STATE HIGHWAY 105 / JACKSON CREEK PARKWAY - PHASE 2

CONSTRUCTION PLANS

Comments provided by DPW Development Services

Comments provided by DPW Capital Projects

JACKSON CREEK PARKWAY SECTION
STA. 26+29.82
SCALE: 1"=10' (H), 1"=5' (V)

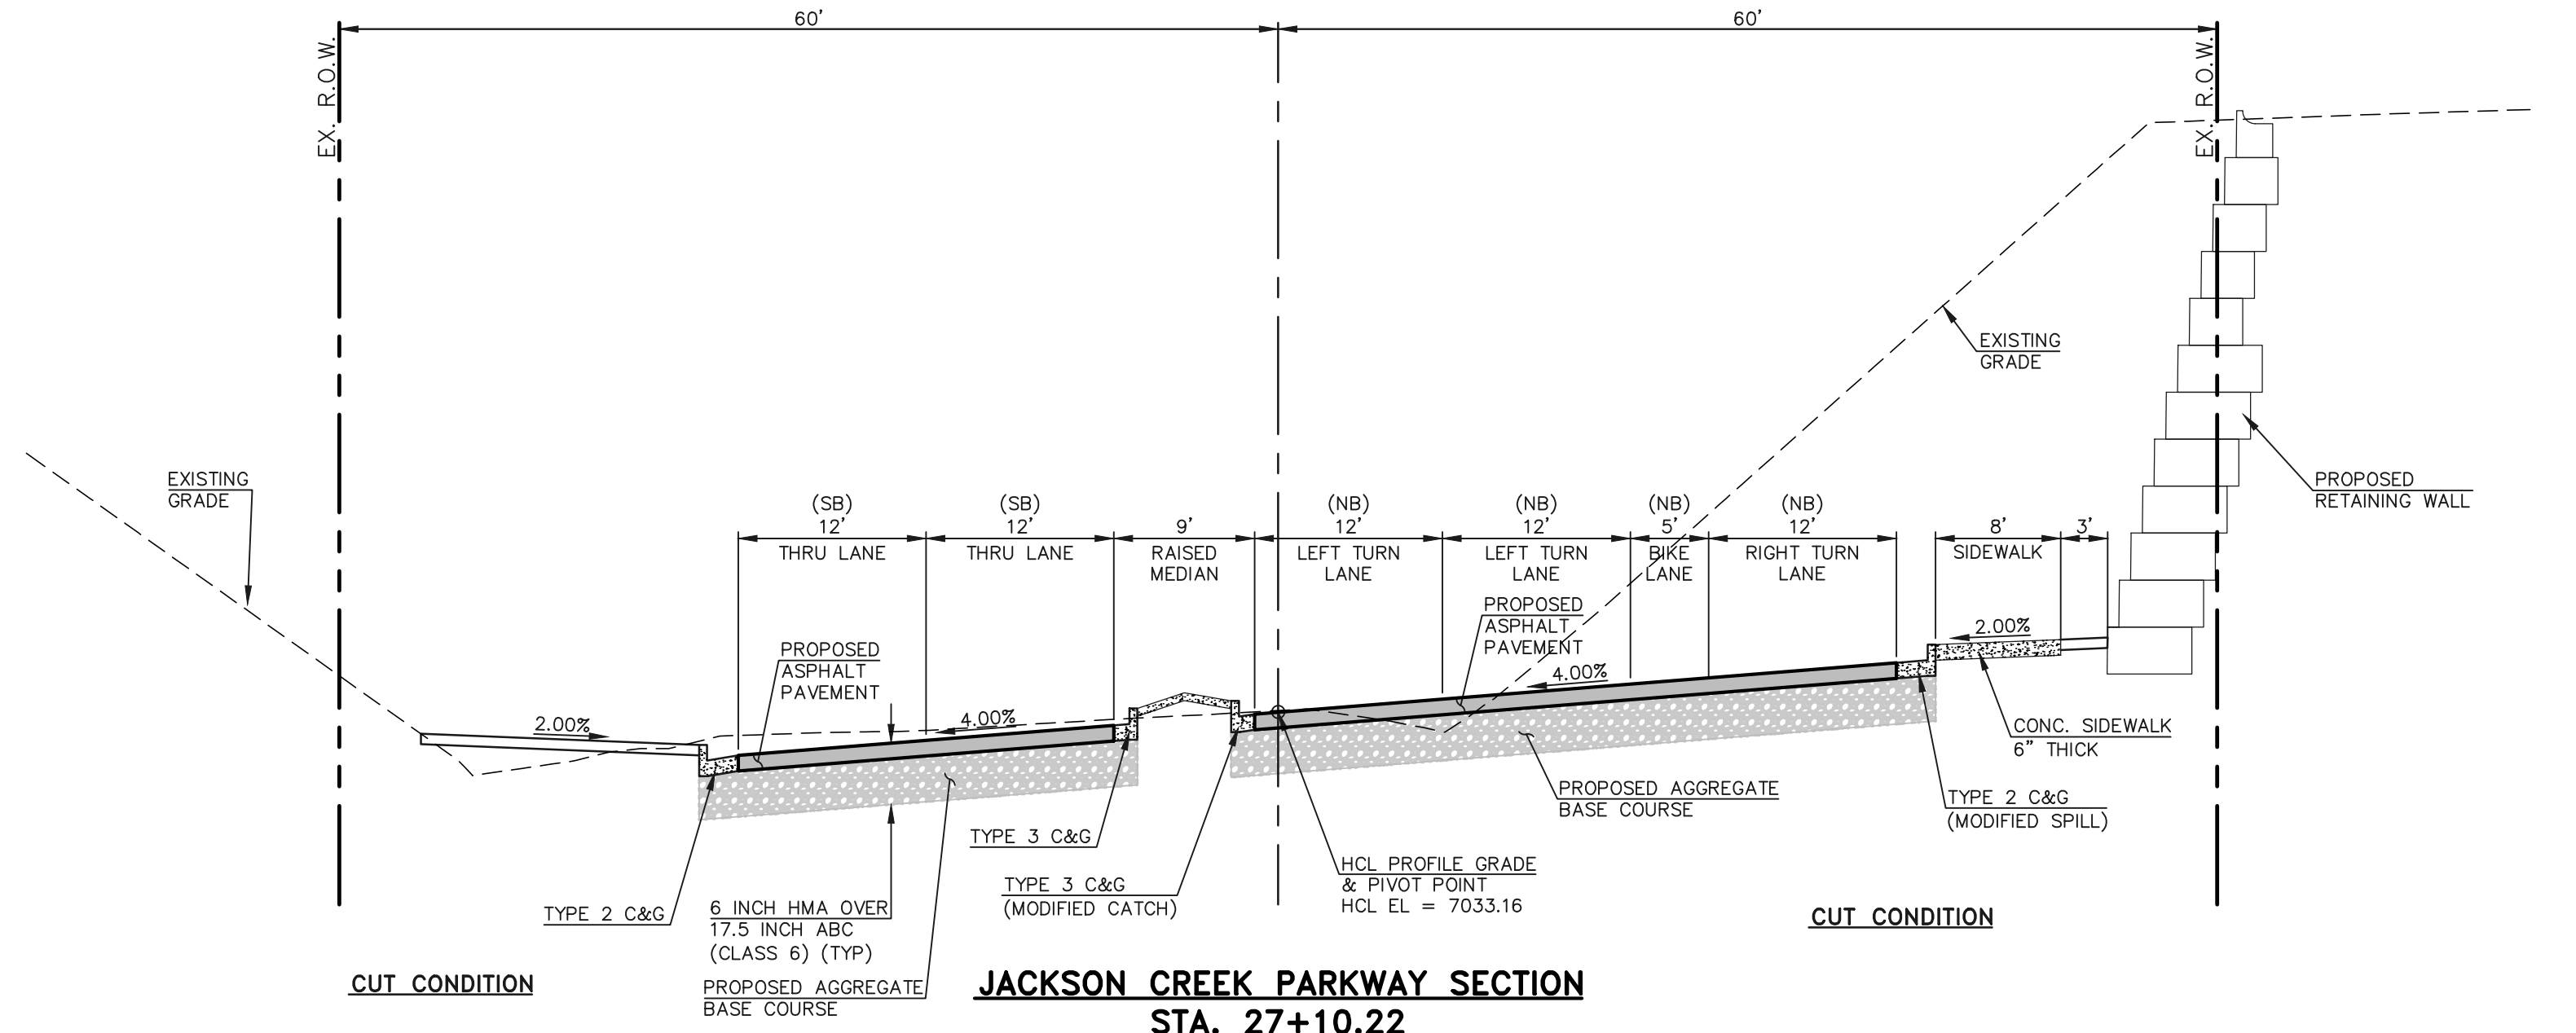
PROVIDE SECTION FOR HWY 105 (EPC). SHOW MILL & OVERLAY DEPTHS ON SECTION. ALSO SHOW ASPHALT AND BASE DEPTHS - SHOULD MATCH HWY 105 DESIGN DEPTHS FOR WIDENED AREA

JACKSON CREEK PARKWAY
(120' ROW - MAJOR COLLECTOR)
DESIGN SPEED 40 MPH

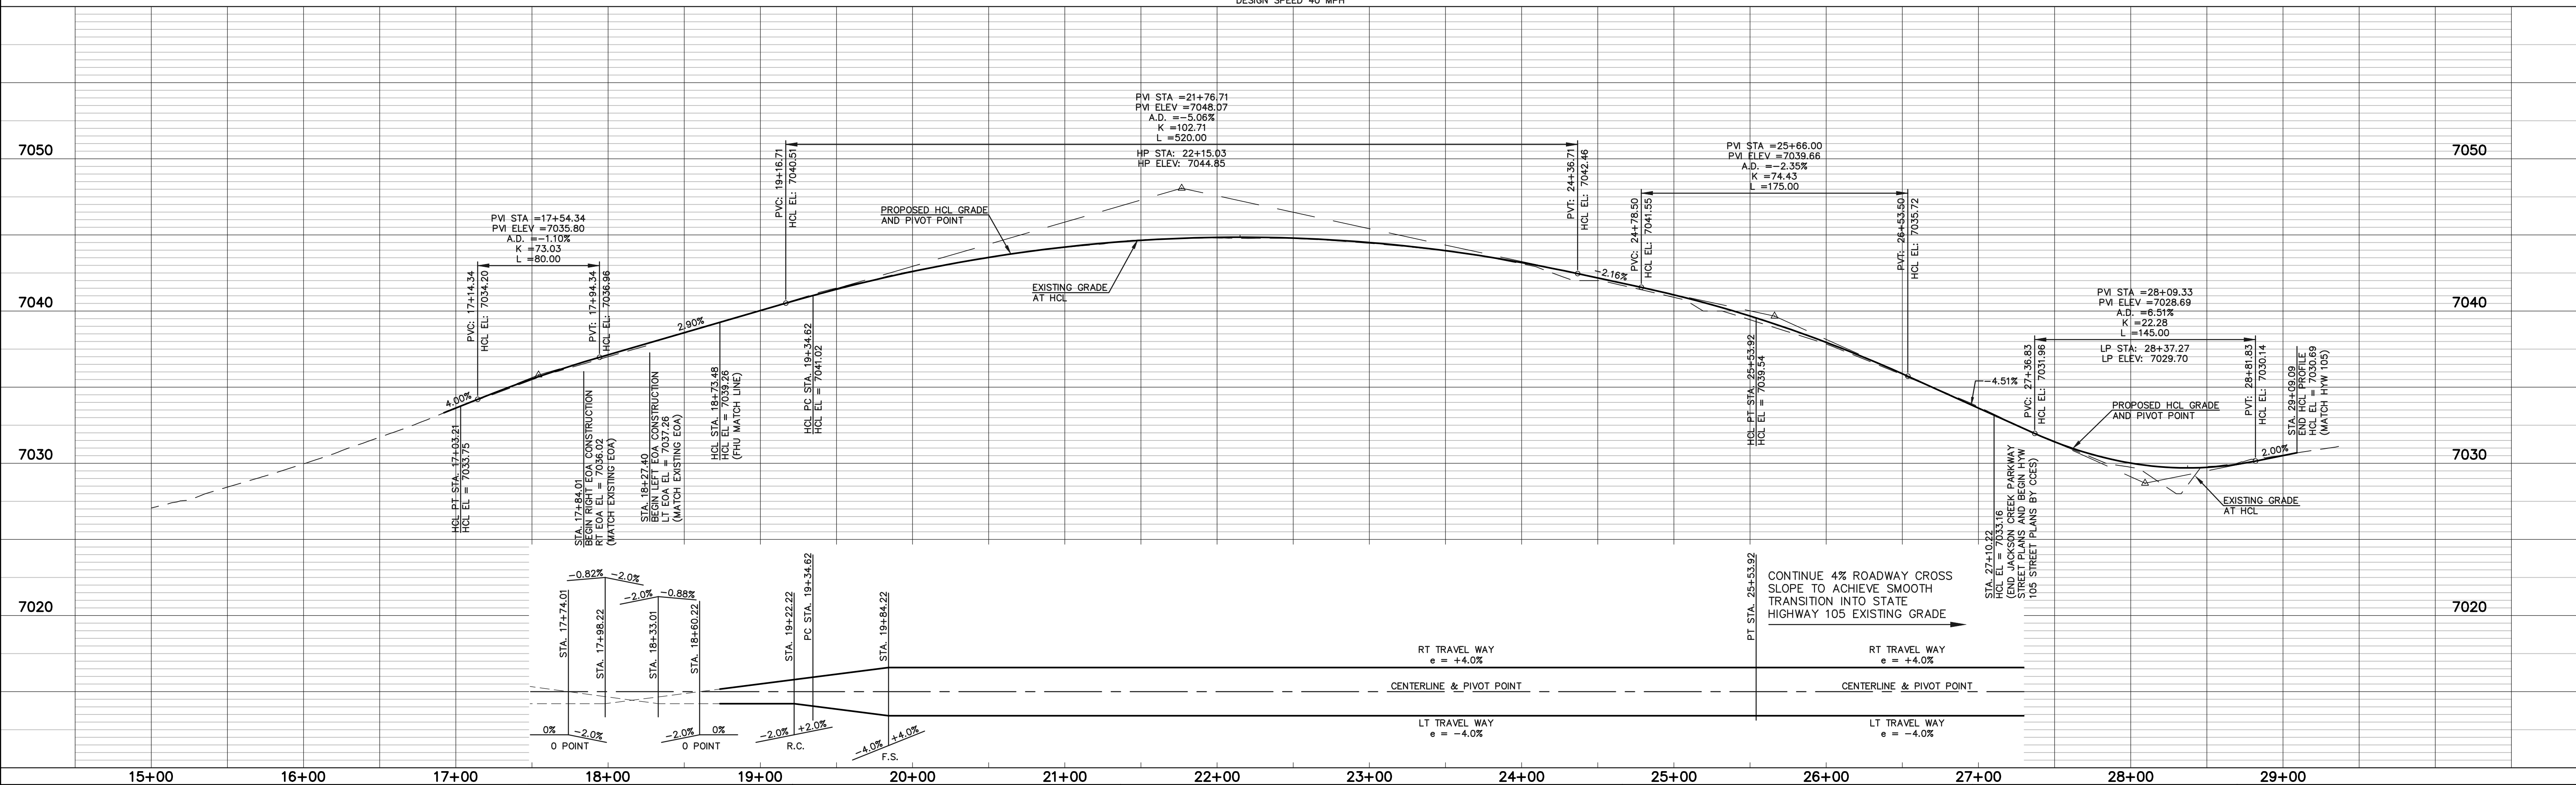
DELETE 'STATE' HERE. CDOT'S STATE HWY 105 IS ON WEST SIDE OF JCP.

JACKSON CREEK PARKWAY
(120' ROW - MAJOR COLLECTOR)
DESIGN SPEED 40 MPH

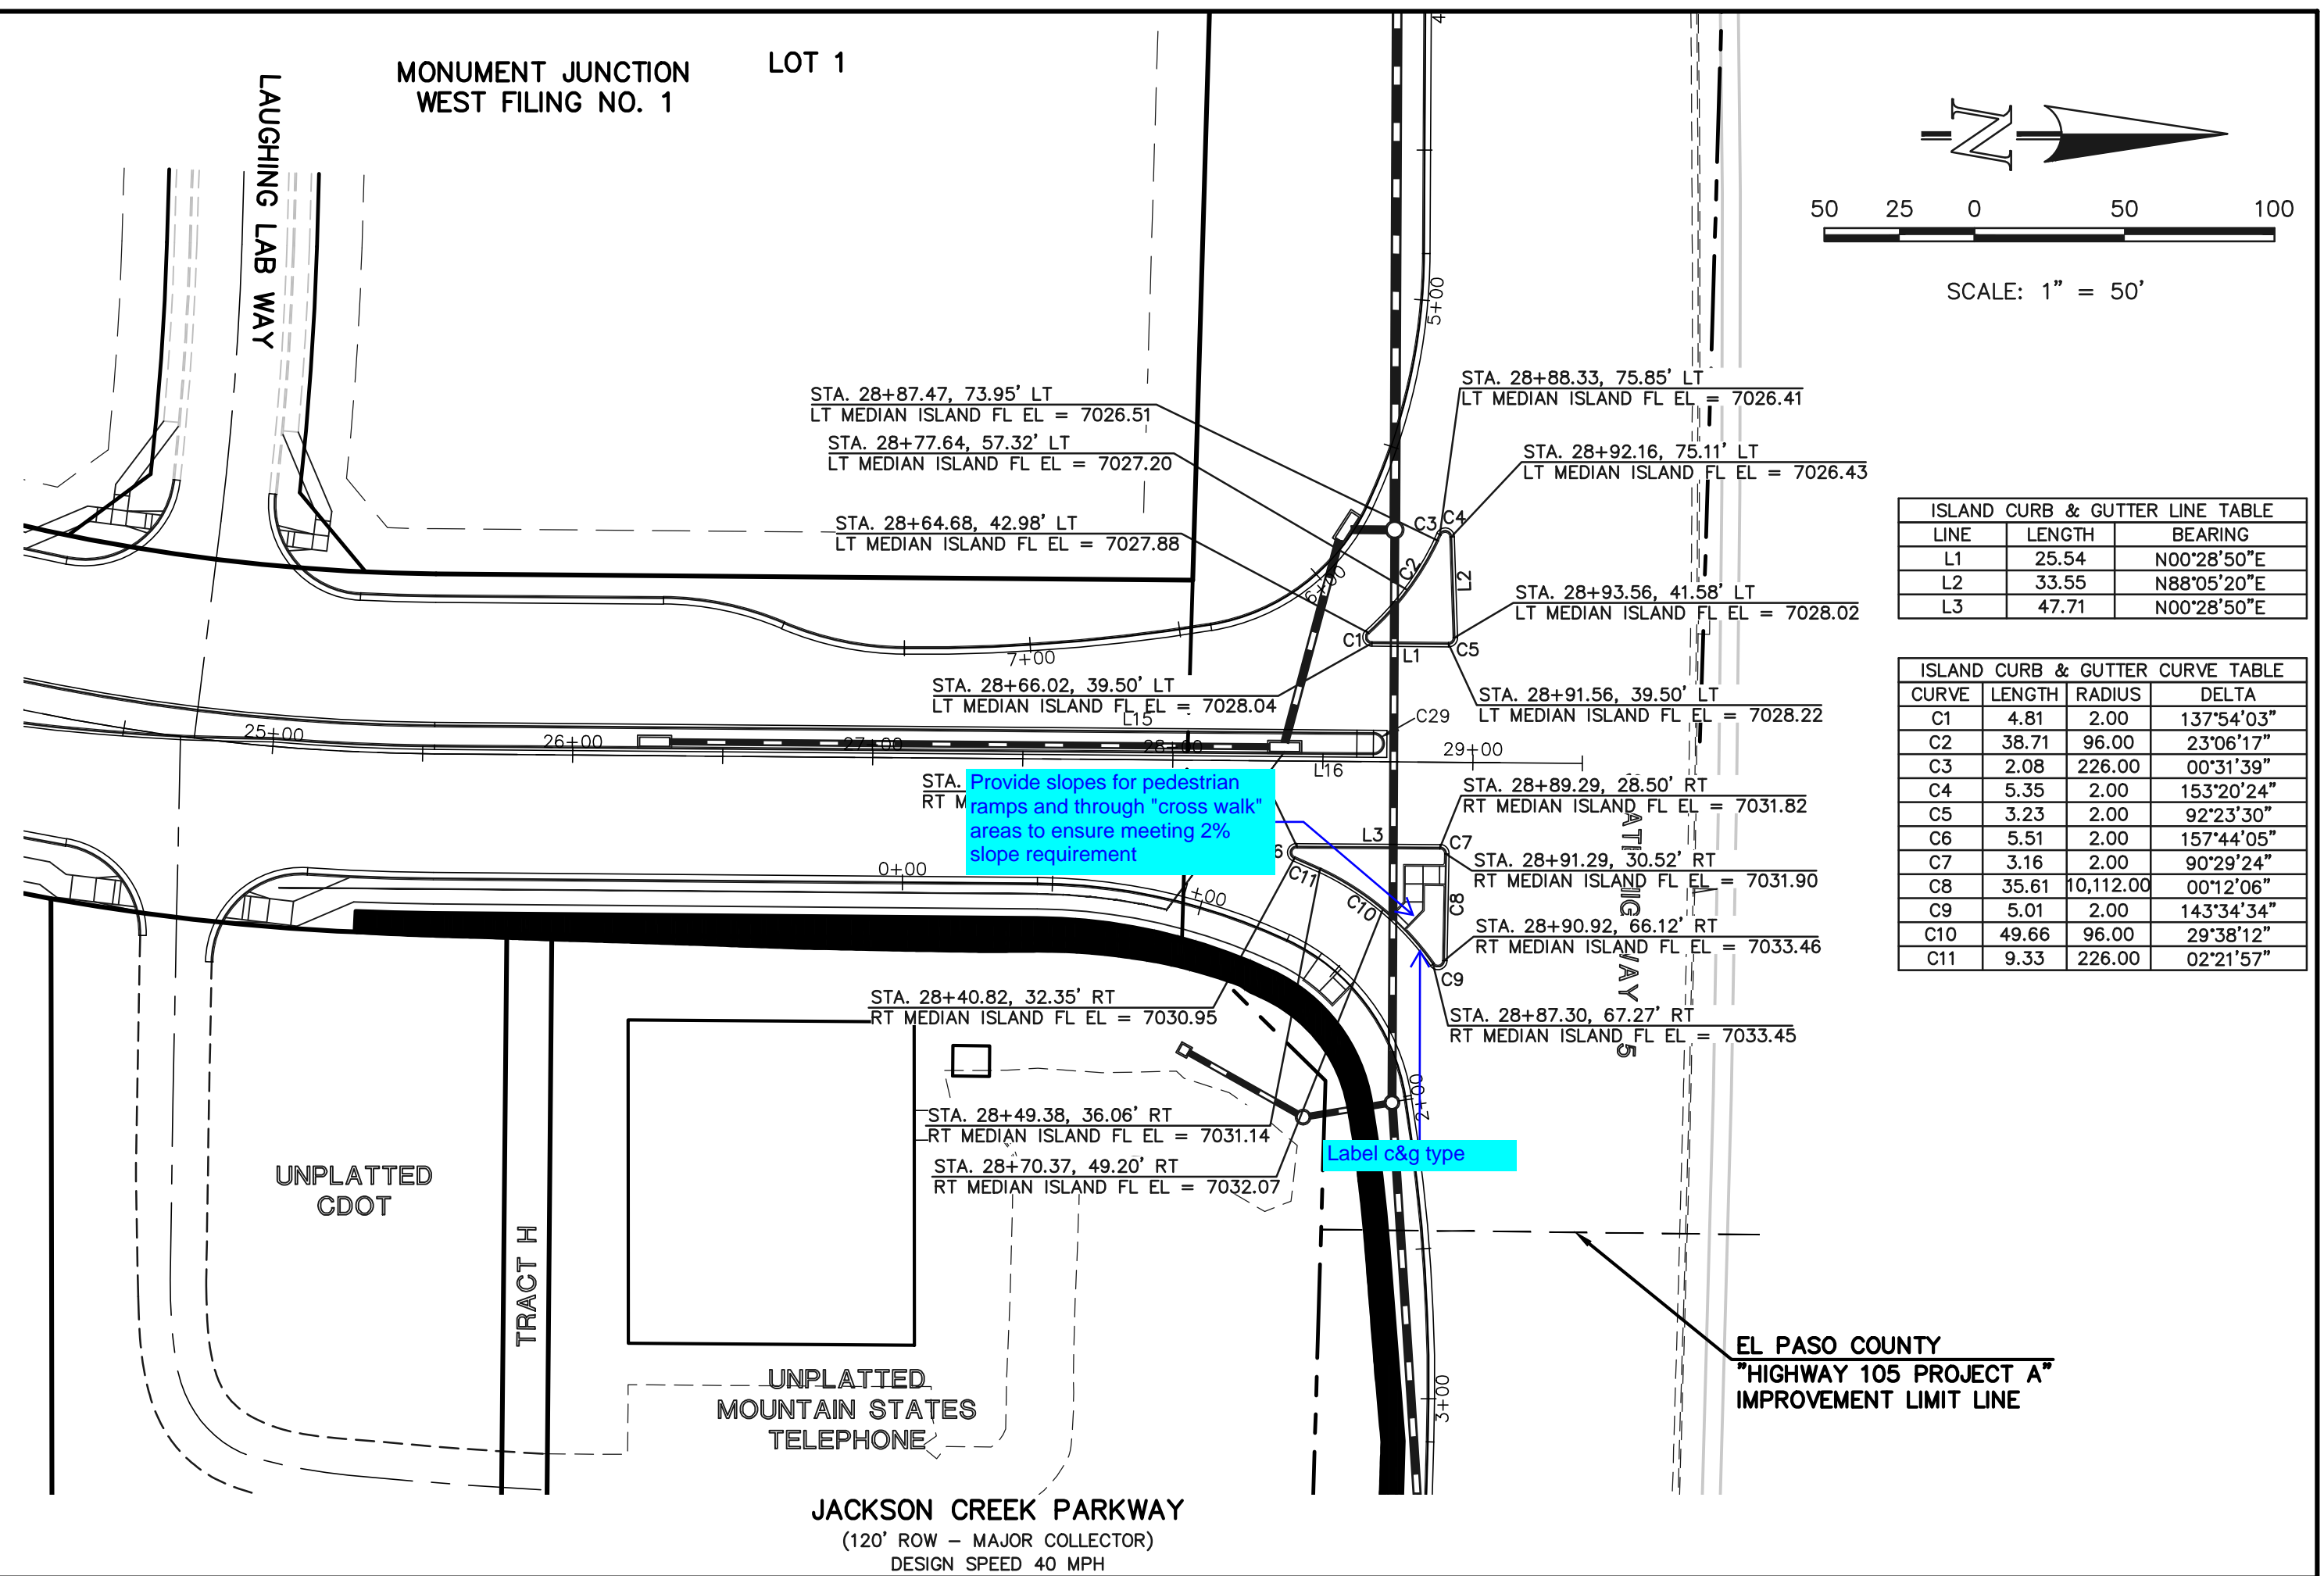
Provide slopes for pedestrian
ramps and through "cross walk"
areas to ensure meeting 2%
slope requirement
